AS BUILT

MAESTRI-MURRELL INC.
MEN'S CLINIC
TENANT BUILDOUT
5207 ESSEN LN. BATON ROUGE, LOUISIANA
BIDDING DOCUMENTS

ARCHBOUTANT
ARCHITECTURE & DESIGN
THIRD PARTY REVIEW FOR LSUCCC
including 2012 IBC performed by
Rick Foster, CBO, CFM for ArchBoutant, LLC

A1 DEMOLITION PLAN

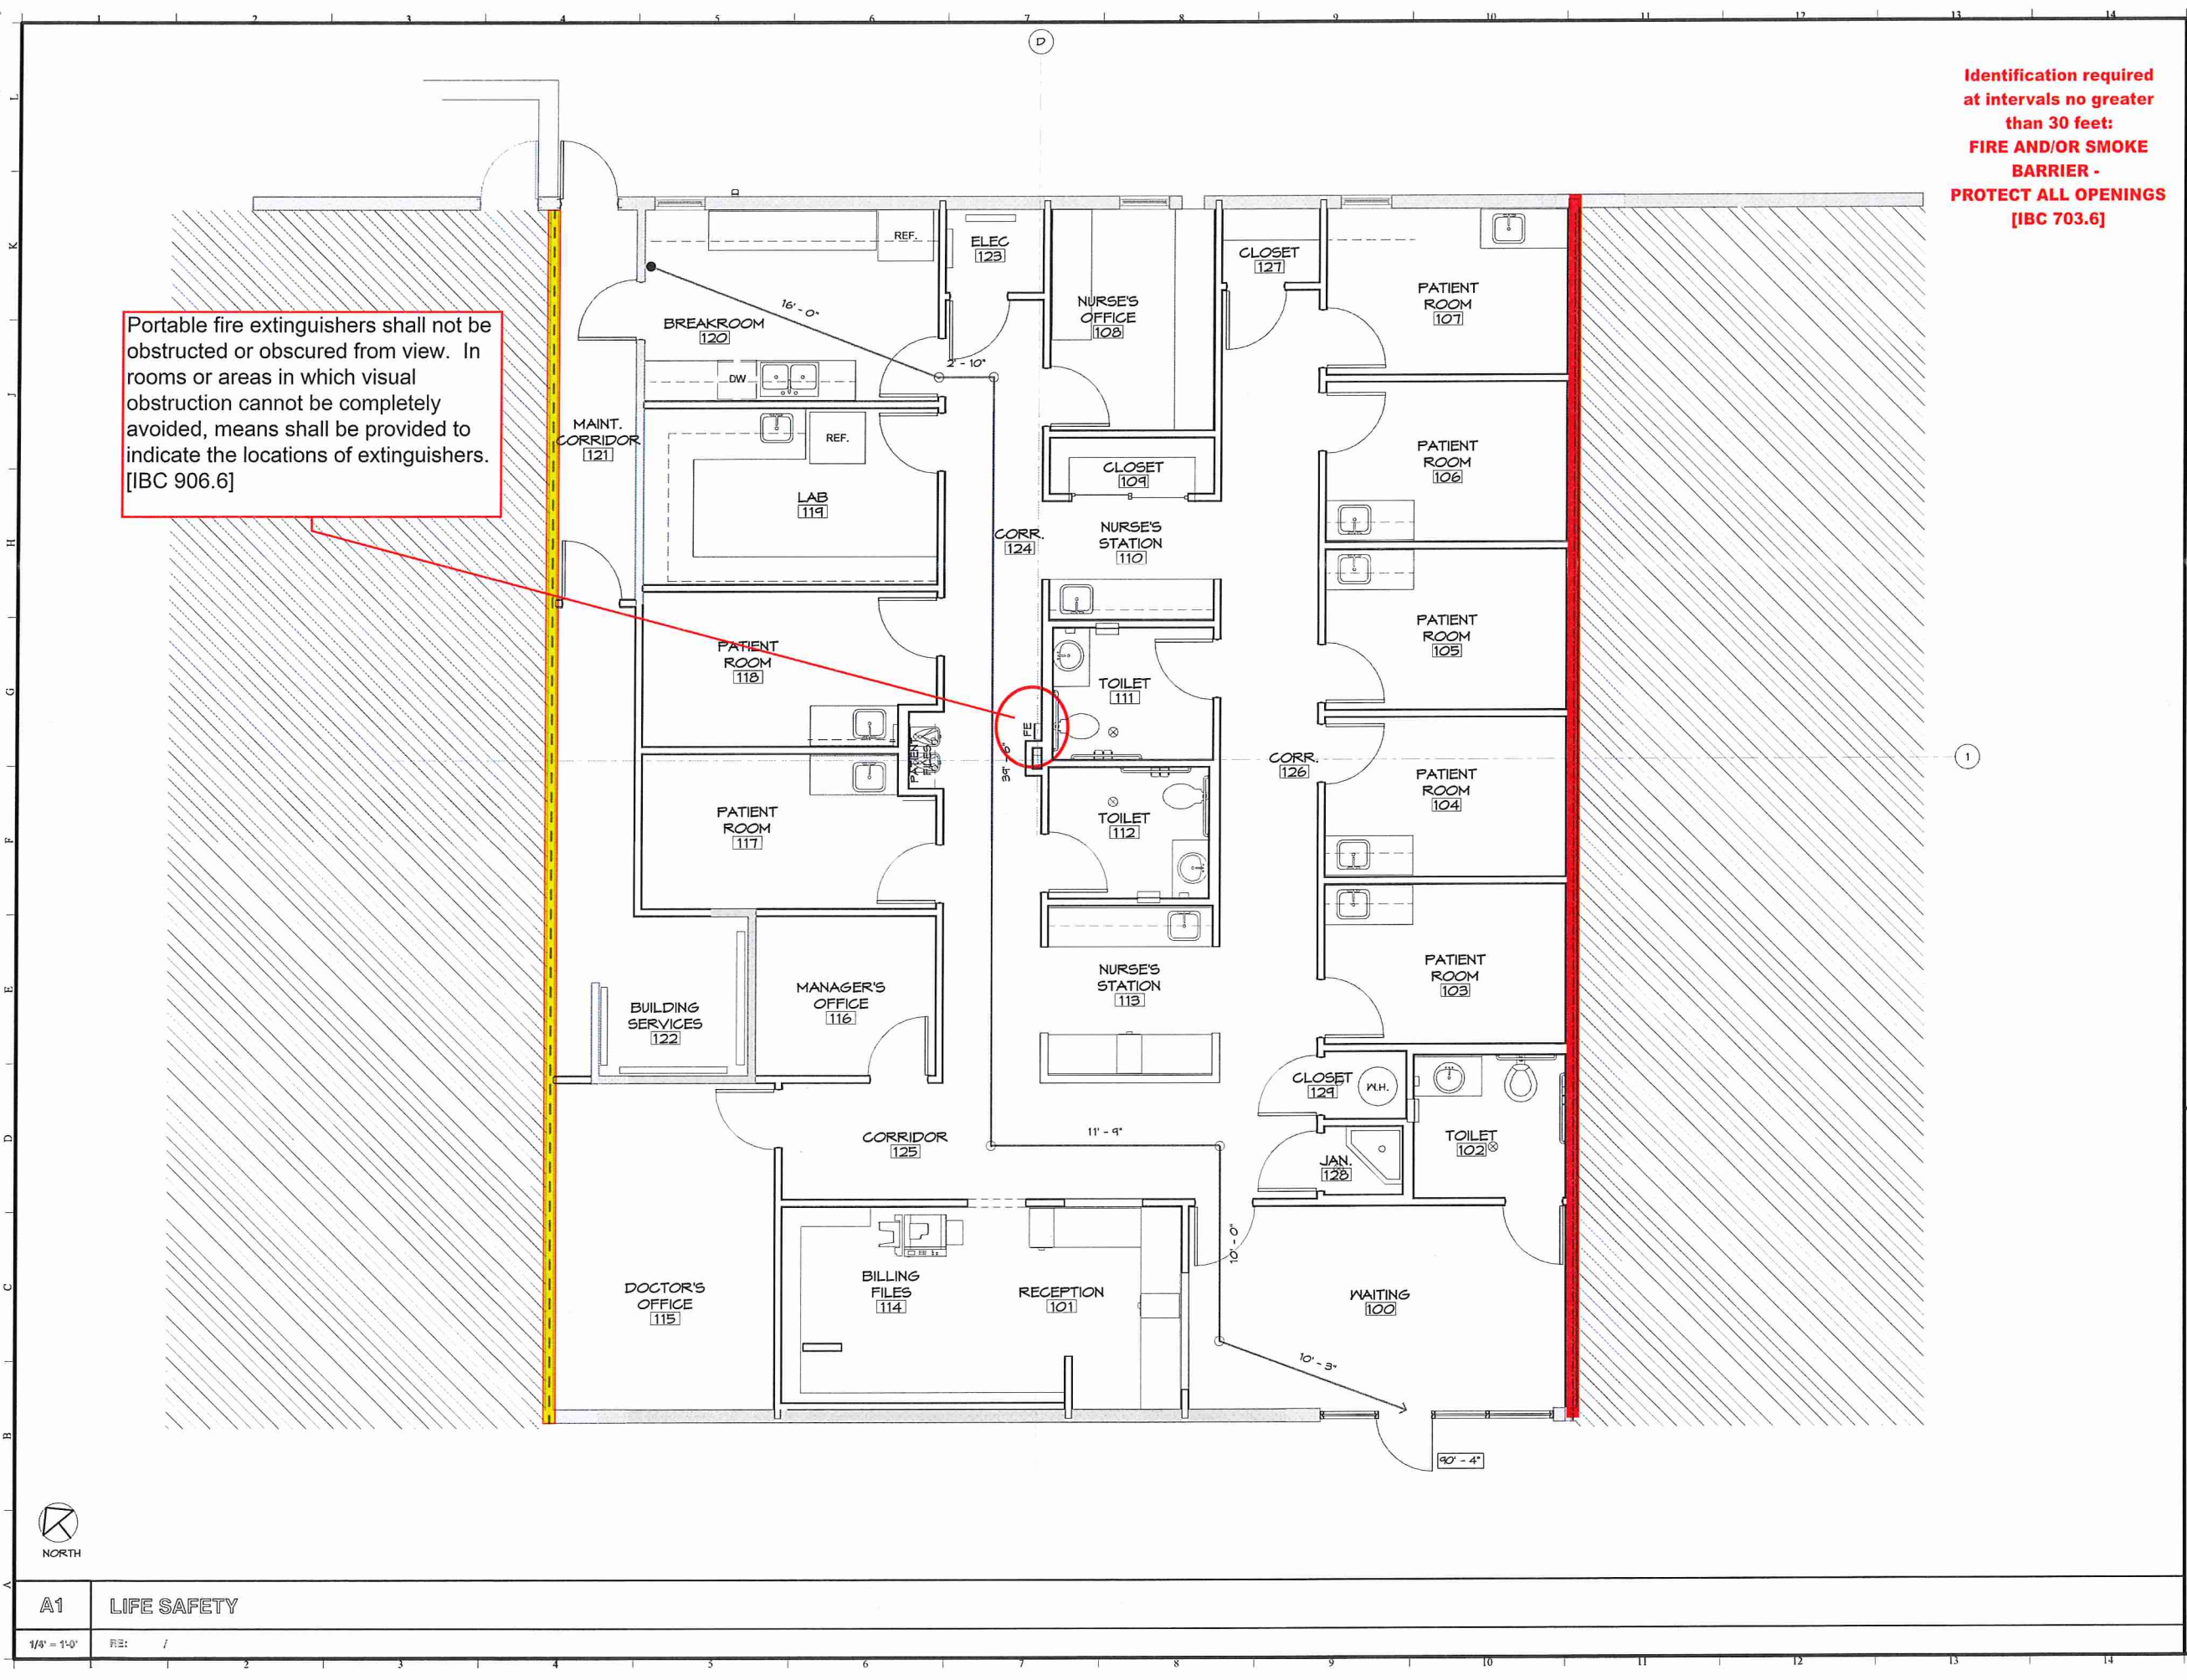
Identification required
at intervals no greater
than 30 feet:
**FIRE AND/OR SMOKE
BARRIER -
PROTECT ALL OPENINGS**
[IBC 703.6]

Portable fire extinguishers shall not be obstructed or obscured from view. In rooms or areas in which visual obstruction cannot be completely avoided, means shall be provided to indicate the locations of extinguishers. [IBC 906.6]

A1 **POWER PLAN**

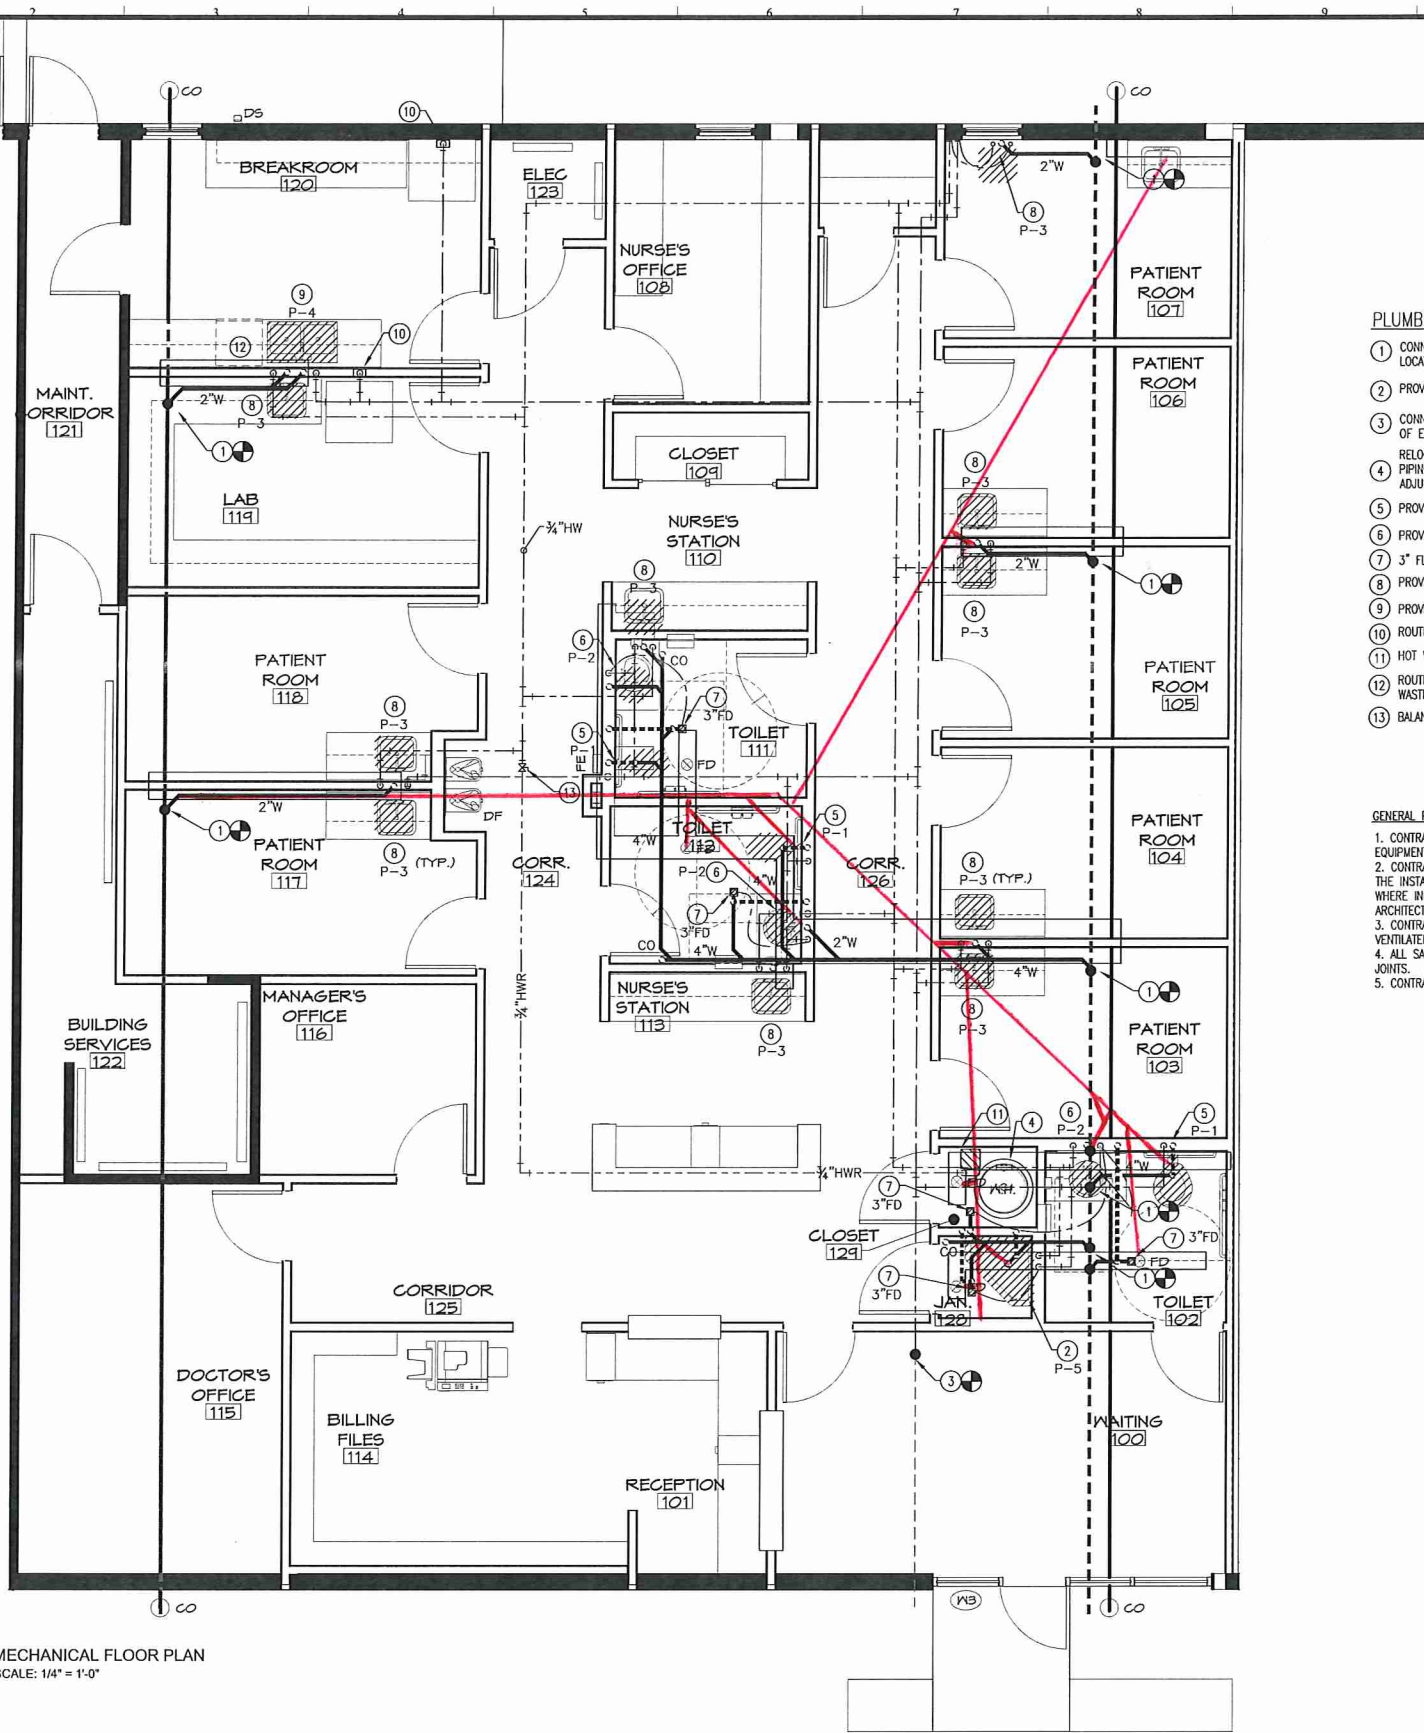
Depth of working space for electrical equipment (including water heater and water heater disconnect, panelboards, etc.) shall not be less than 36" and the width shall not be less than 30". [NEC 110.26(1 & 2)]

A1 LIGHTING PLAN
1/8" = 1'-0"

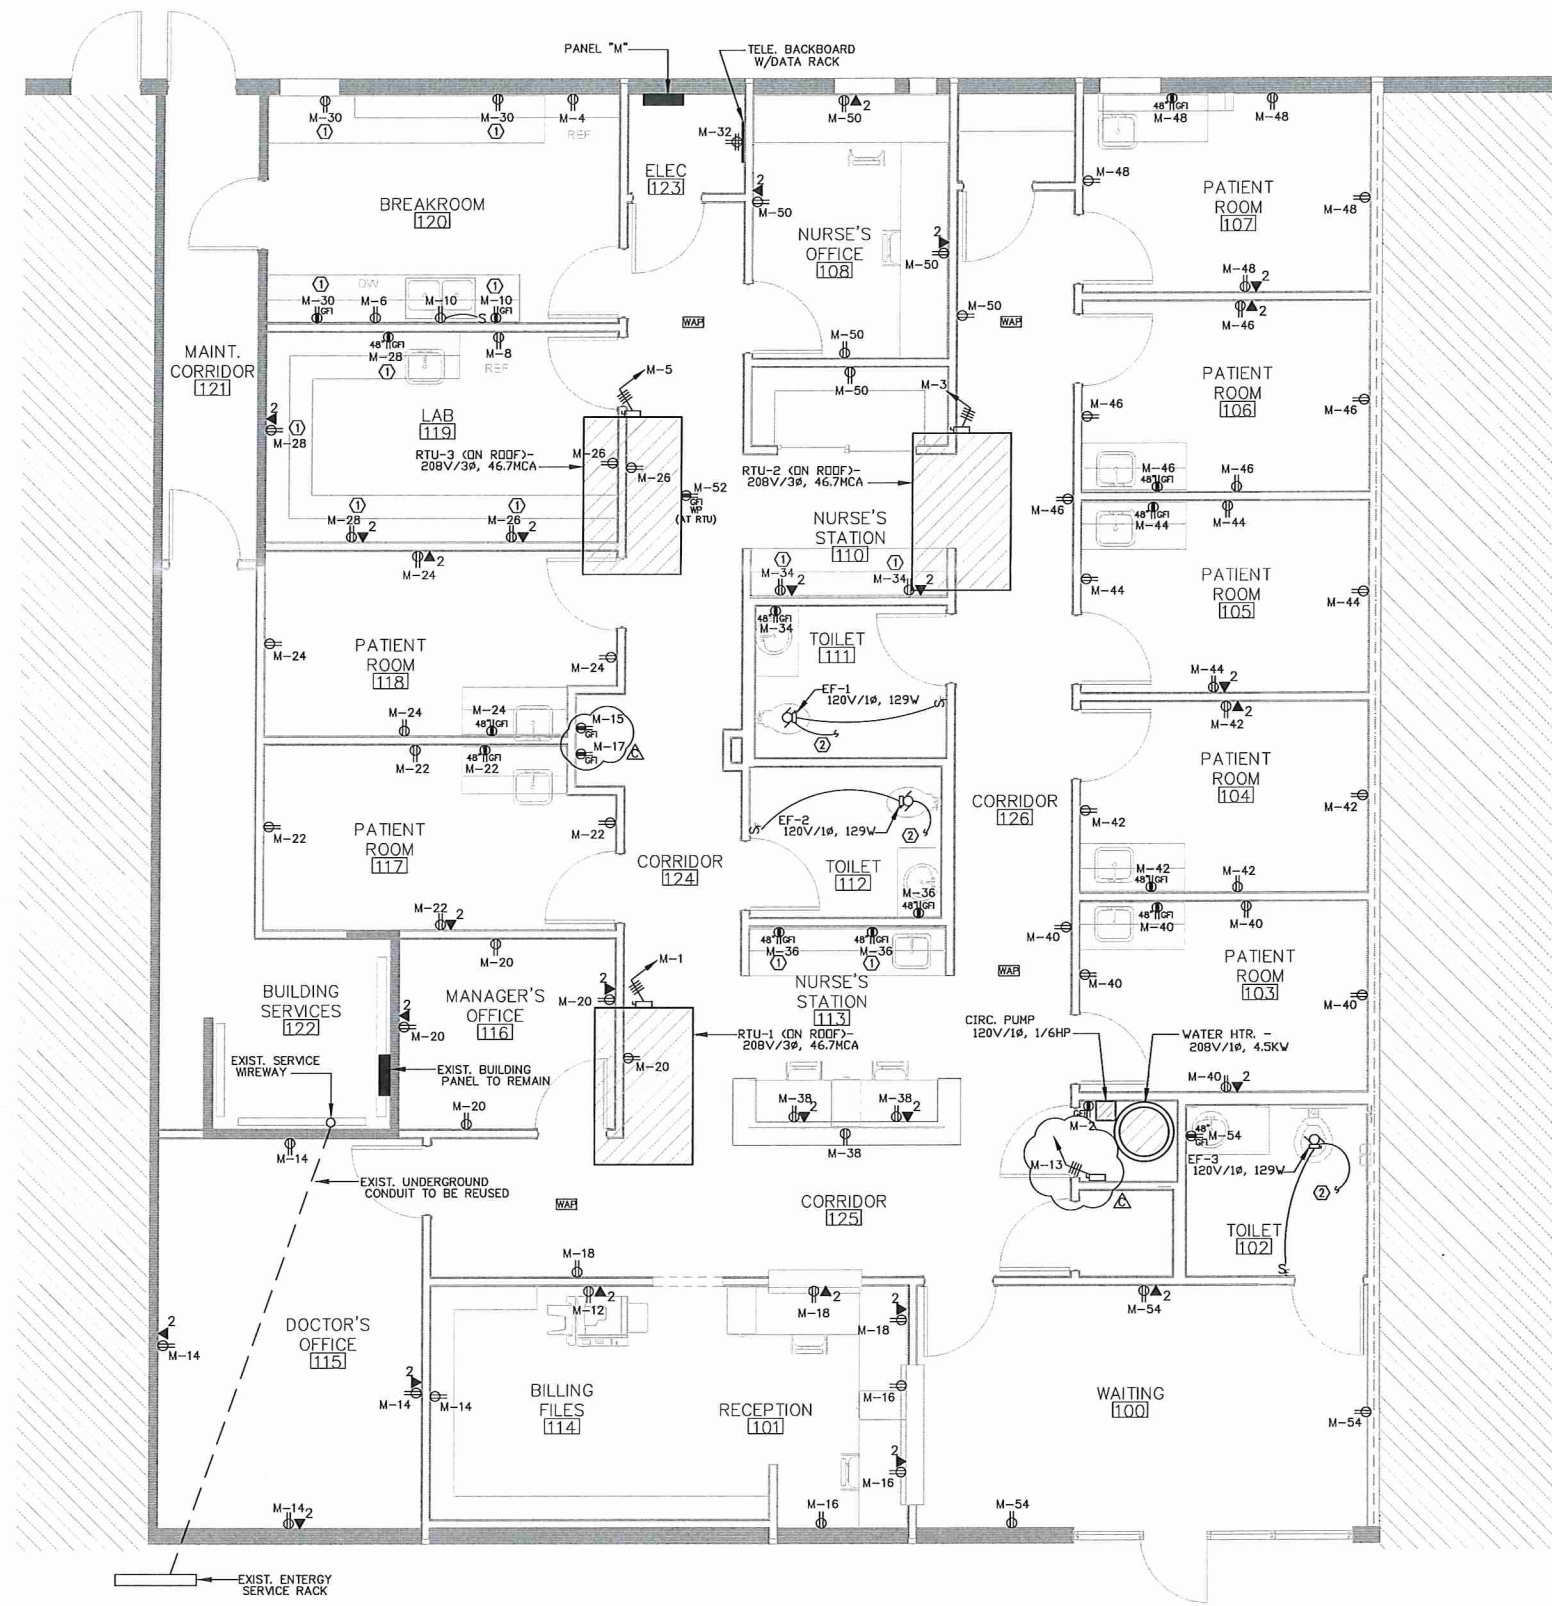
The power supply for means of egress illumination shall normally be provided by the premises' electrical supply. In the event of power supply failure, an emergency electrical system shall automatically illuminate the exterior landing(s) for exit discharge doorways in buildings required to have two or more exits. The emergency power system shall provide power for a duration of not less than 90 minutes and shall consist of storage batteries, unit equipment or an on-site generator. [IBC 1006.3]

* See A400 for light changes
